Hydromodification and Hydrologic Controls

Ventura County Co-Permittee Comments

April 18, 2008

Figure 1:

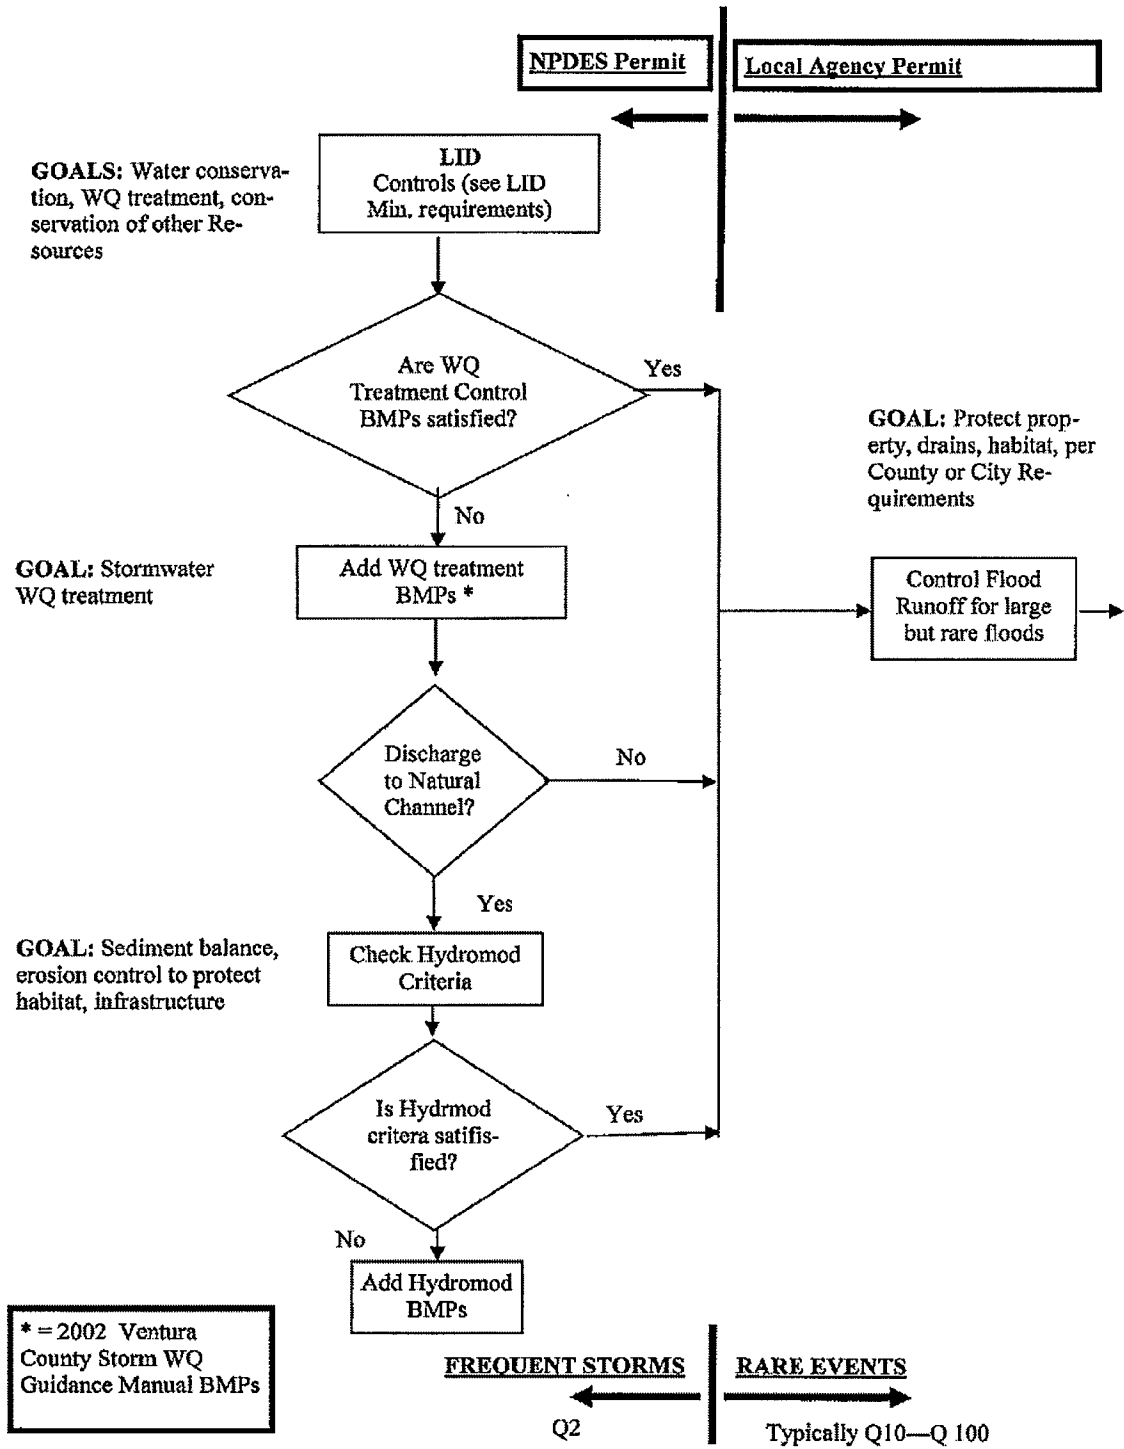
The permit should recognize the interdependence of hydrologic controls and a sequencing of analysis to take this into account - beginning with what can be done with LID measures, then check for water quality mitigation and finally Hydromodification for any remaining runoff. See

recommended flow chart in **Figure 1**. The Ventura County Technical Guidance Manual and Section 5.E.III.1 should be modified to add this recognition and flow chart for hydrologic controls to the permit. Suggested language is in Attachment C.

Figure 1.13: Factors affecting channel degradation and aggradation. The "size" of the channel is determined by the stream's energy, the slope, and the flow of water in balance with the size and quantity of the sediment particles the stream moves.

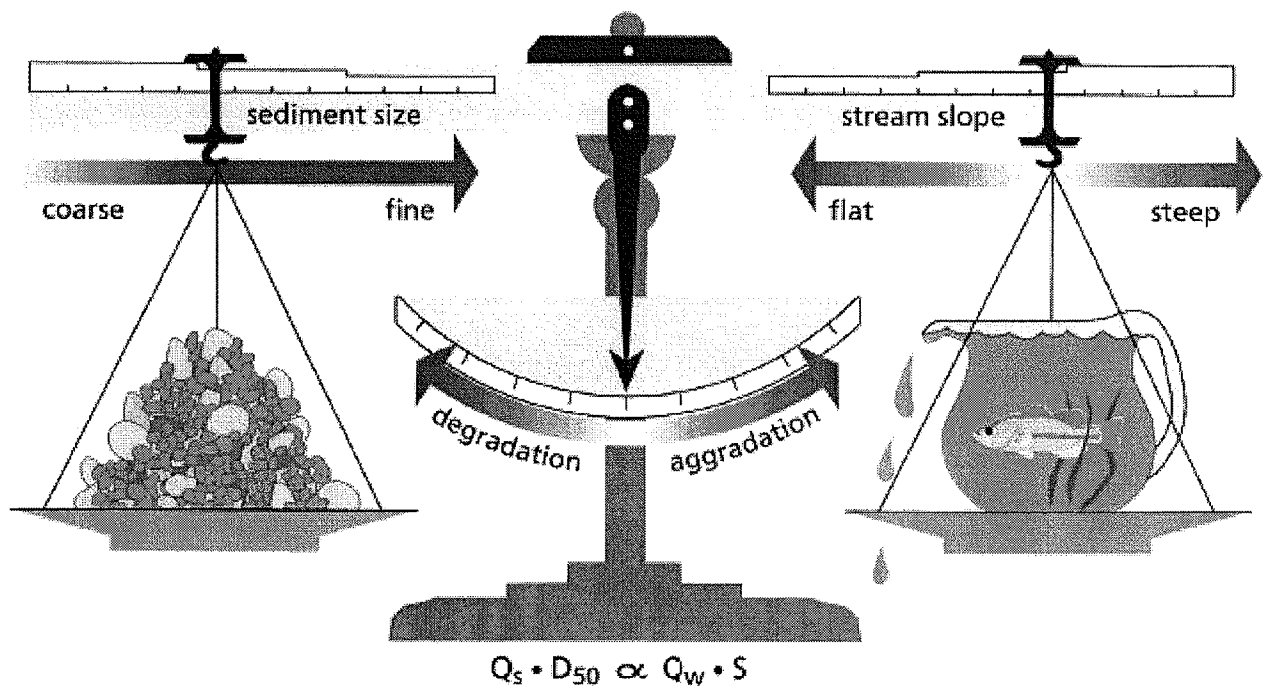
Relationship of Sediment and Flow

Increasing Flow or Decreasing Sediment Load Cause Degradation of Channel

Four Variables that affect the channel erosion or aggradation:
